UNIT 2 TECHNICAL SPECIFICATION

LIST OF EFFECTIVE PAGES

UNIT 2 TECHNICAL SPECIFICATION

Figure 3.1-1

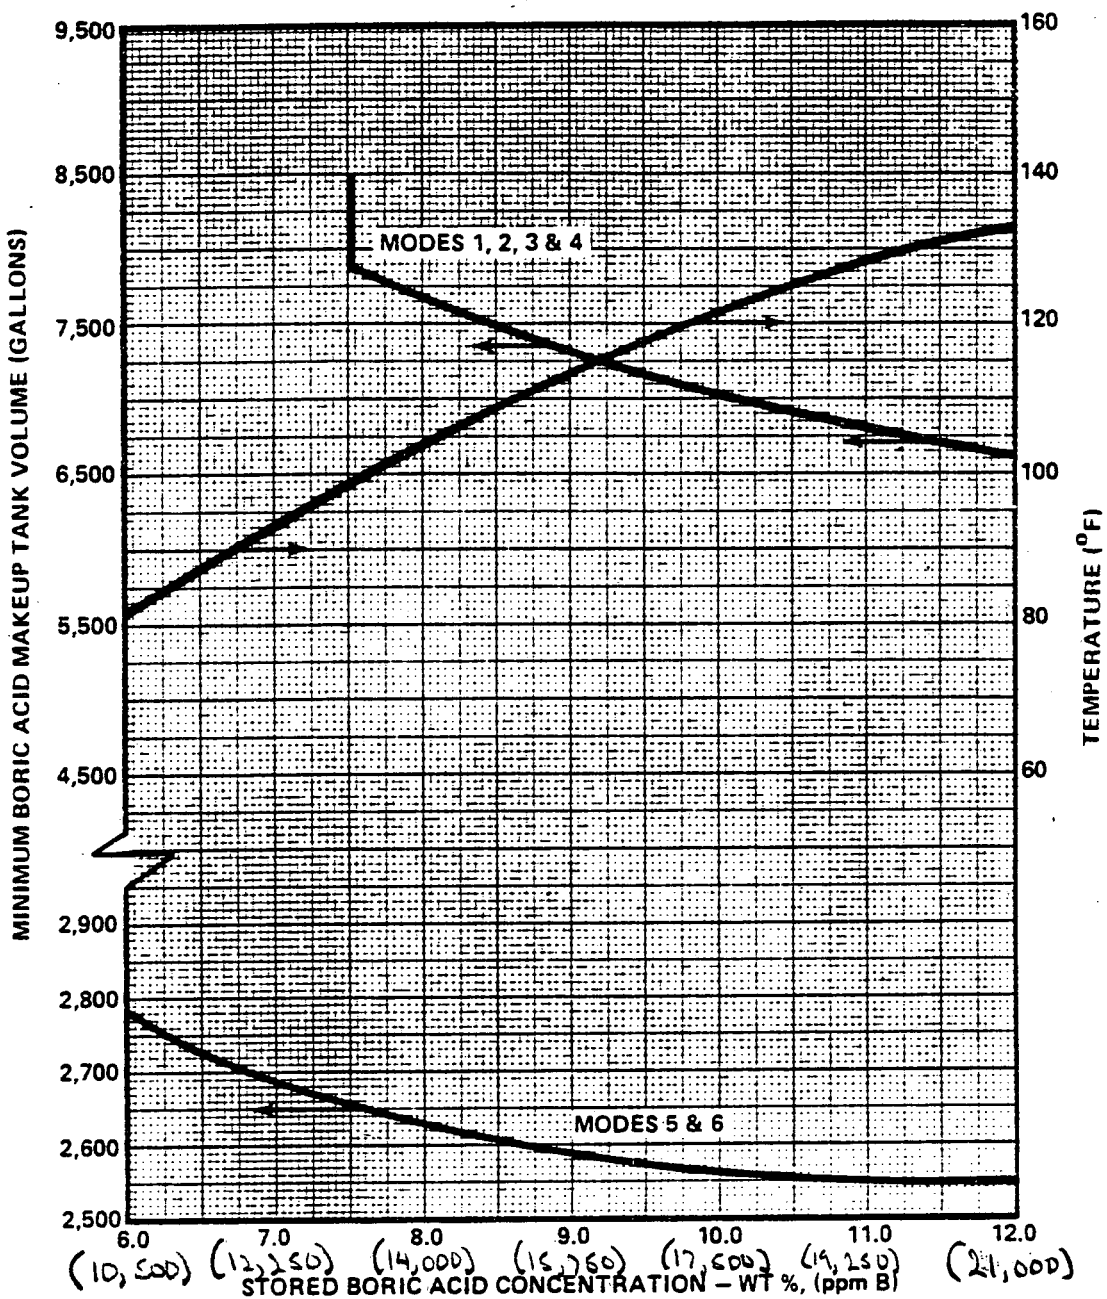
revise to include unrecoverable volume

Figure 3.3-1

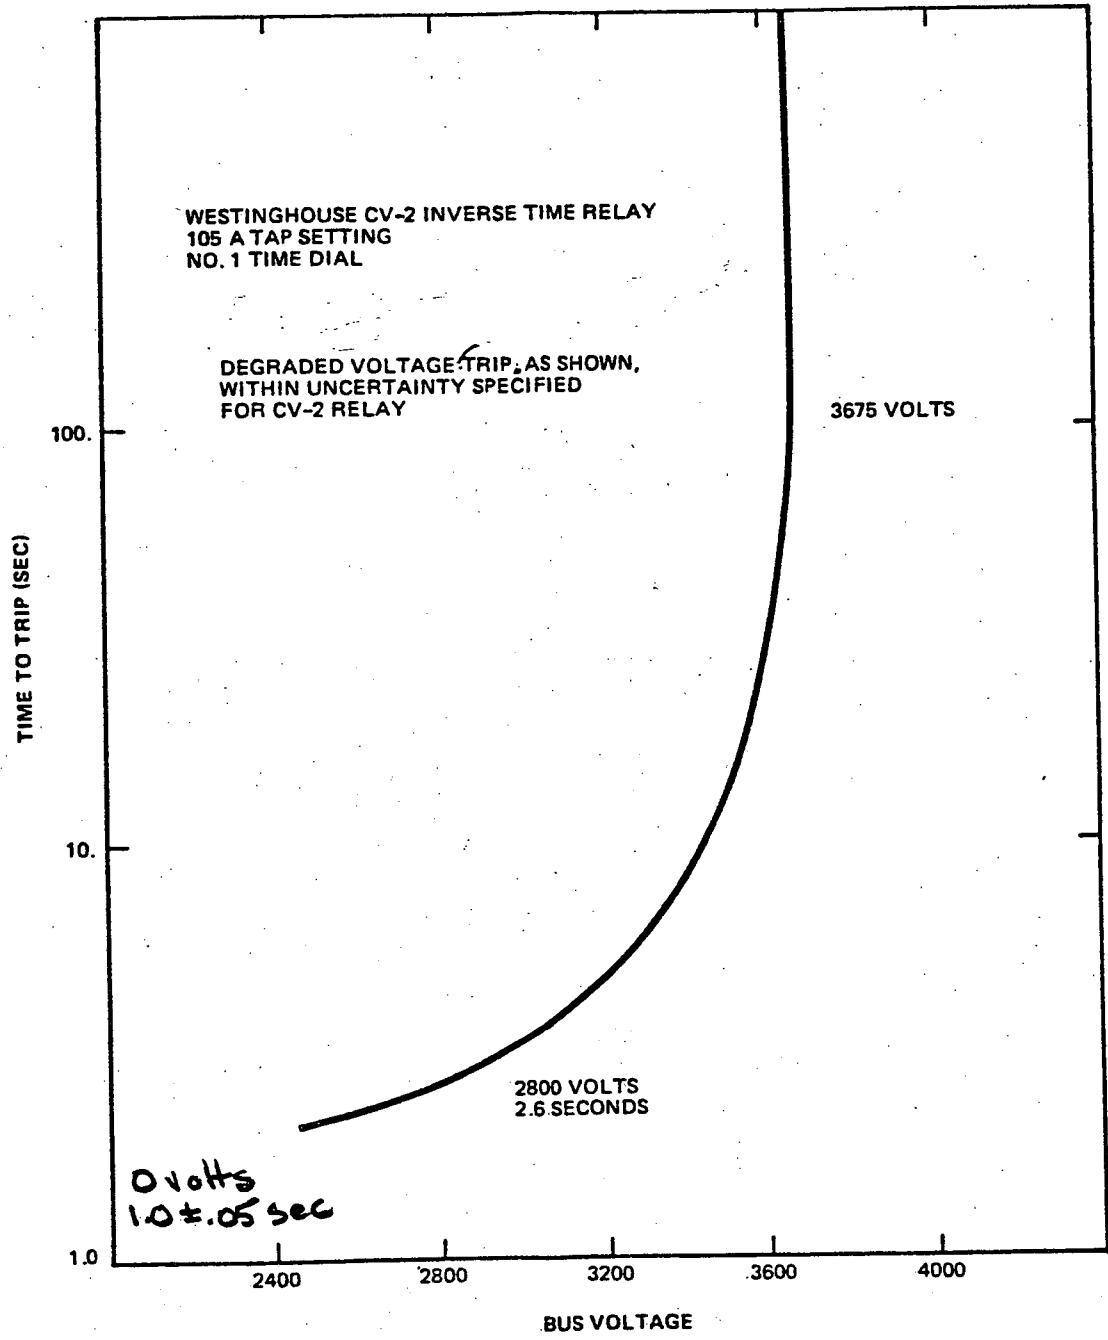
SAR
 analysis
 set pts

(4) Inverse time relay set value 3165 V; trip will occur within the tolerances specified in Figure 3.3-1 for the range of bus voltages. X

Figure 4.4-1
~~5.1.51~~

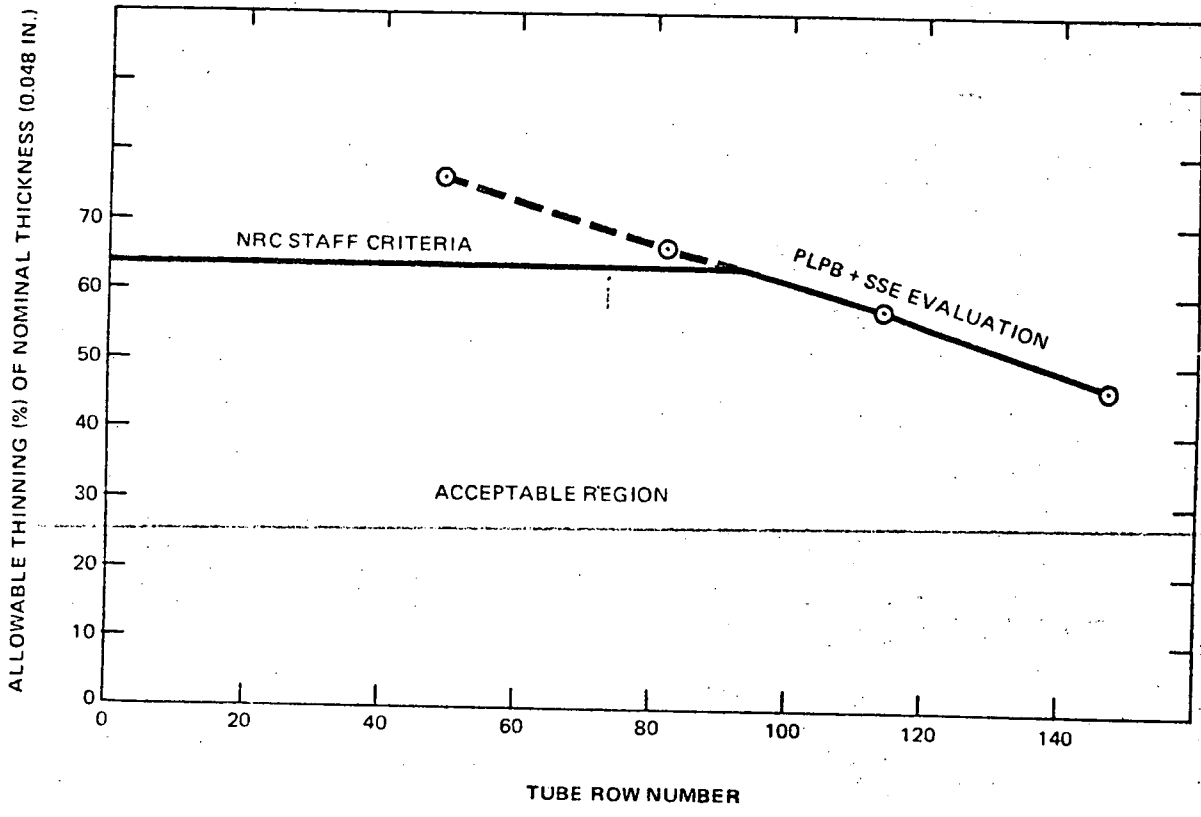
4.5. Defect means an imperfection of such severity that it exceeds the plugging limit. ~~A tube containing a defect is defective.~~
Shown in figure 4.4-1.

~~6. Plugging Limit means the imperfection depth at or beyond which the tube shall be removed from service and is equal to (40)%* of the nominal tube wall thickness, as determined in Figure 4.4-1.~~

3.12-1
 FIGURE 3.18.1 TERRESTRIAL MONITORING FOR THE
 RADIOLOGICAL ENVIRONMENTAL
 MONITORING PROGRAM

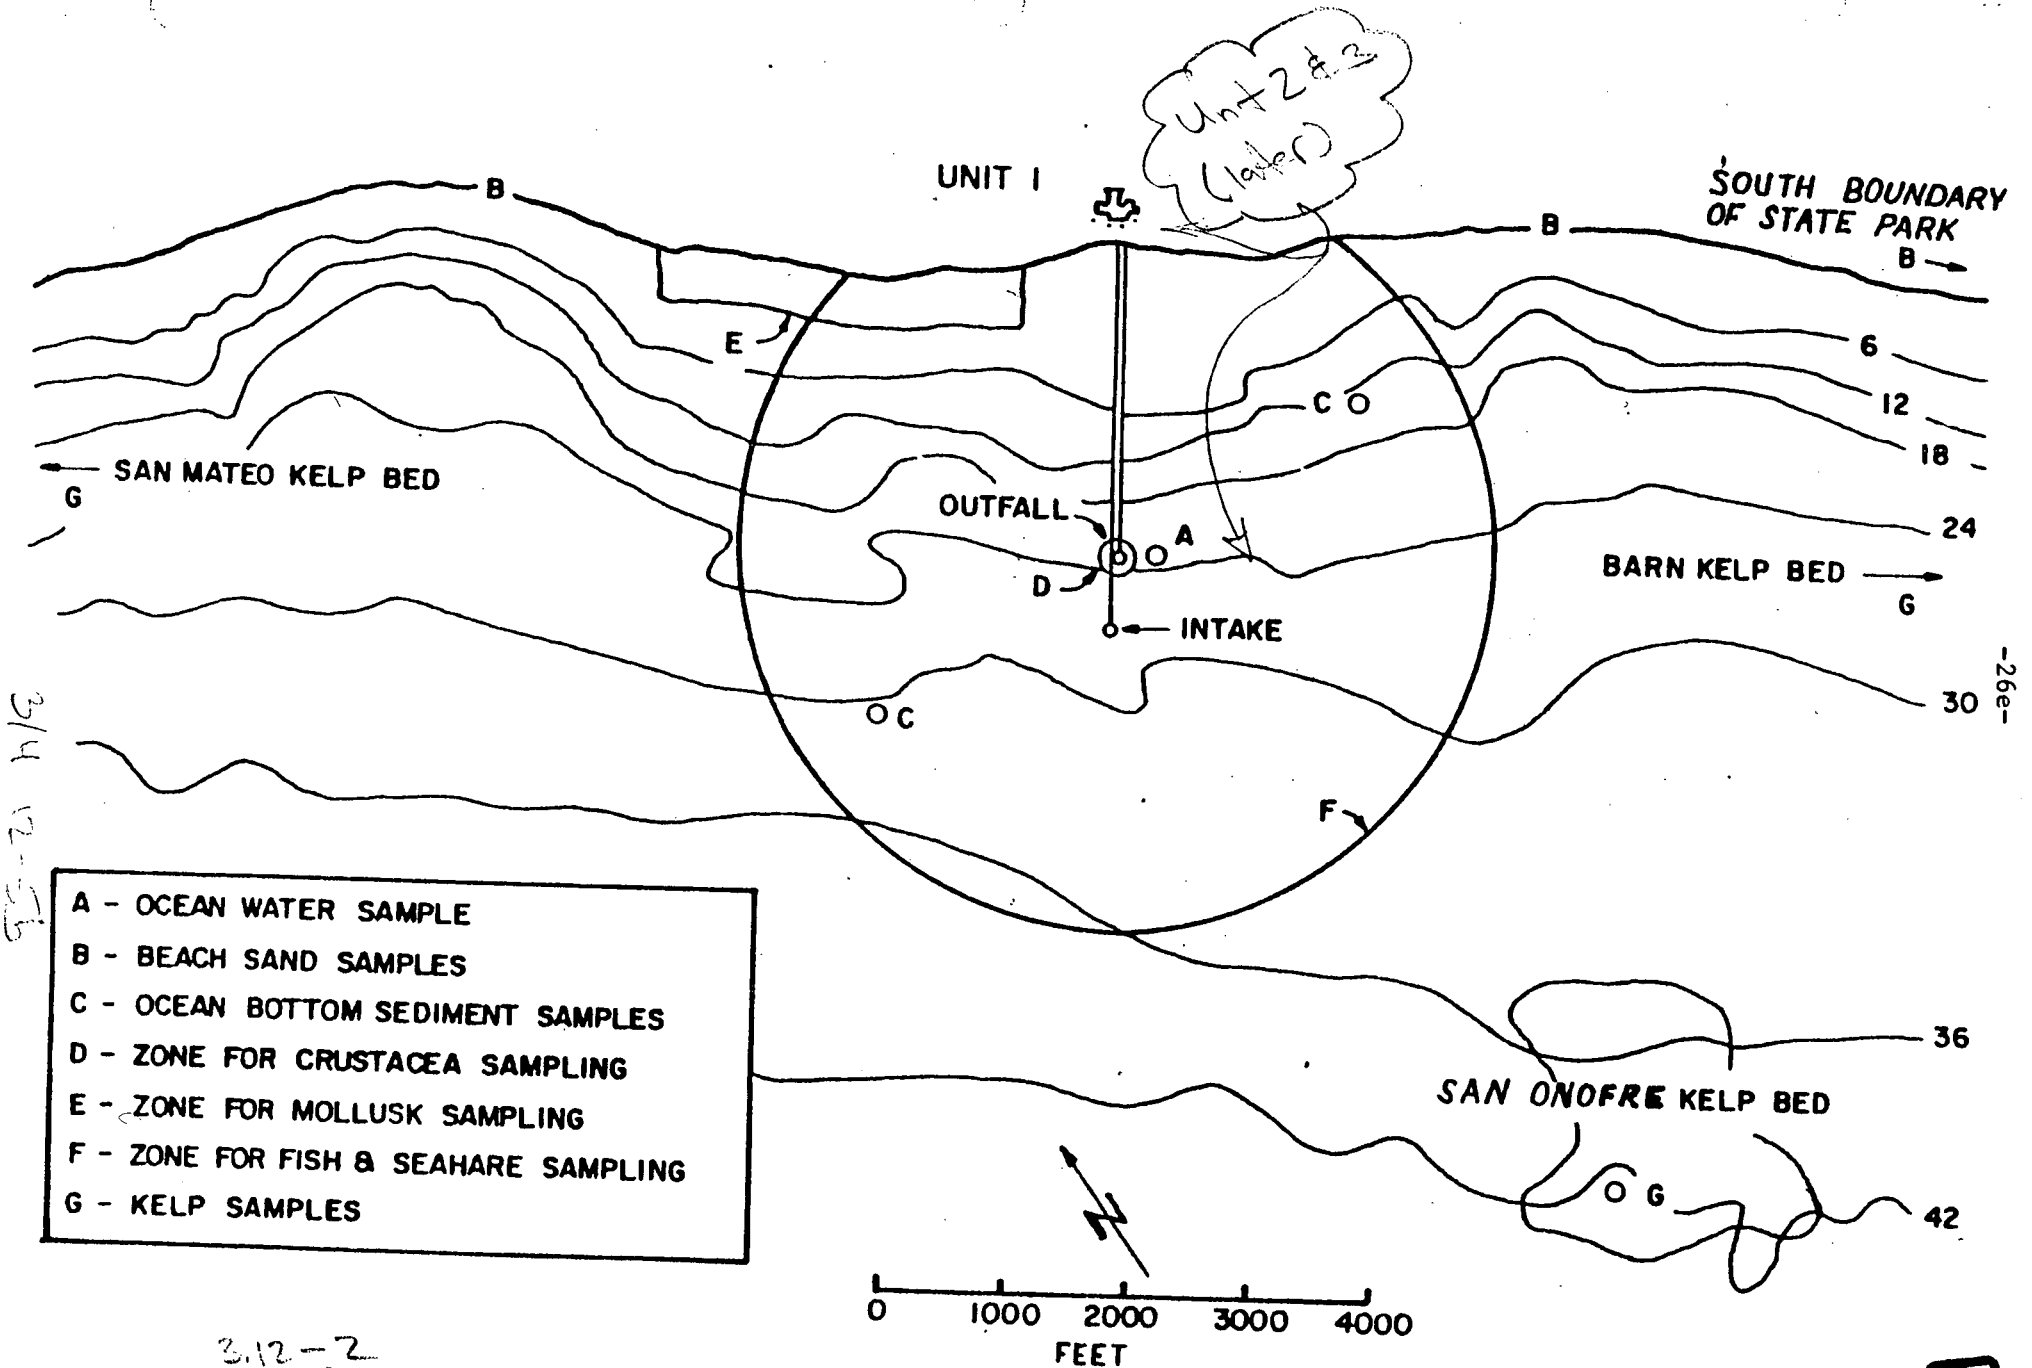
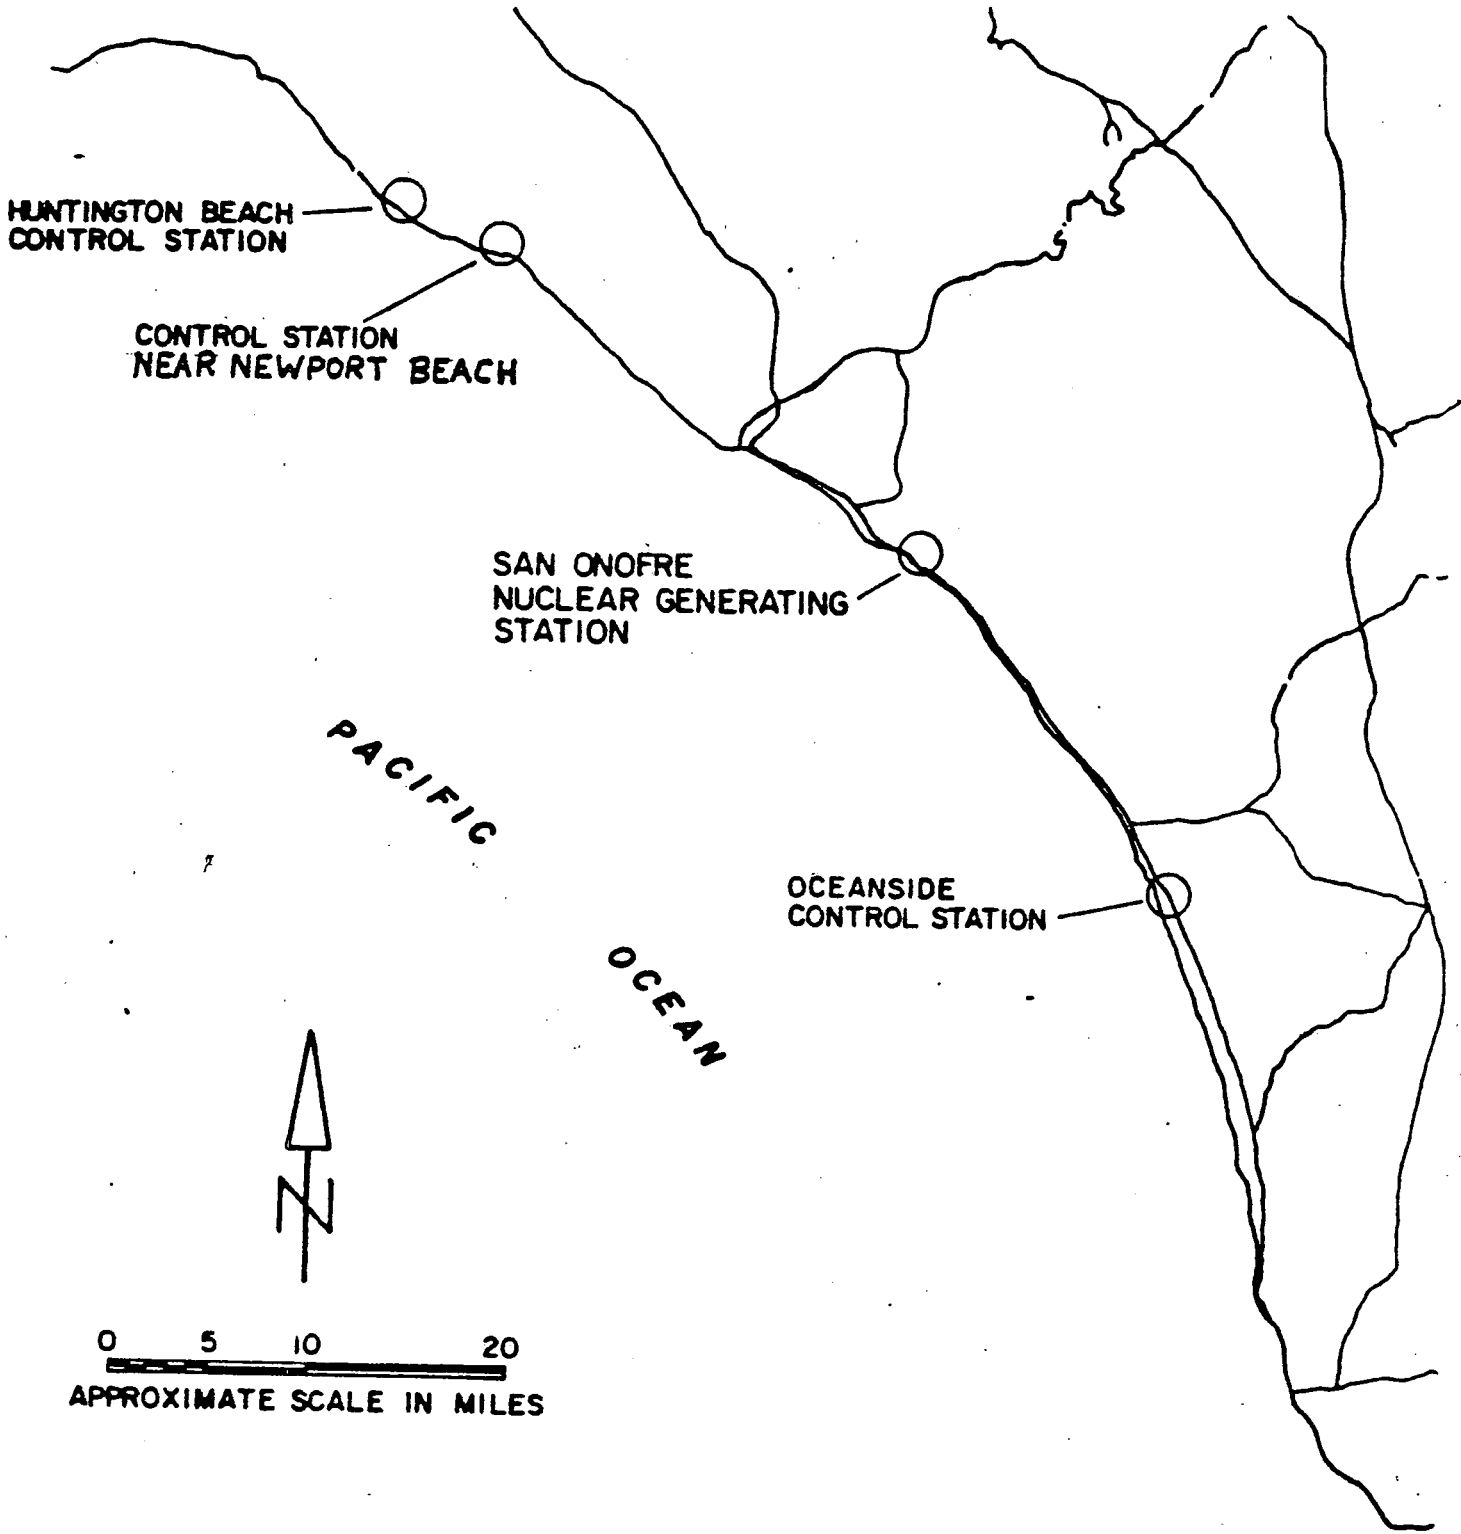
- (1) See Figure ~~3-18.1~~ 3.12-1
 (2) See Figure ~~3-18.2~~ 3.12-2
 (3) See Figure 3.12-3
